November 28, 2001

SUBJECT: Datron World Communications, Inc.
FCC ID: B3TG25RPV100
731 Confirmation No.: EA102146
Correspondence Ref. No.: 21037

On behalf of Datron is our response to the SAR items 1-9 of your e-mail dated October 23, 2001 requesting additional information for the subject application.

Body-worn SAR Test Setup
with 1.5cm separation distance

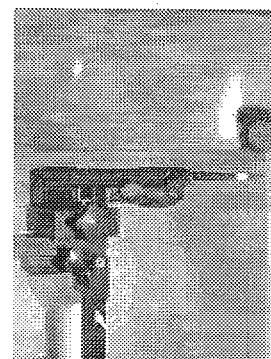
1. Attached are the revised SAR data tables showing the "before and after" power measurements.
2. The date of the system validation was August 9, 2001 as reported on the validation plot in Appendix B - Dipole Validation.

1. The SAR values found were below the maximum limit of 8.0 w/kg (controlled exposure).
2. The highest body-worn SAR value found was 4.94 w/kg (100% duty cycle).
3. The EUT was tested for body-worn SAR with a 1.5cm separation distance between the back of the EUT and the outer surface of the planar phantom.
4. See Appendix B for explanation of phantom thickness.
5. Ambient TEMPERATURE: 22.4 °C
Relative HUMIDITY: 56.2 %
Atmospheric PRESSURE: 95.3 kPa
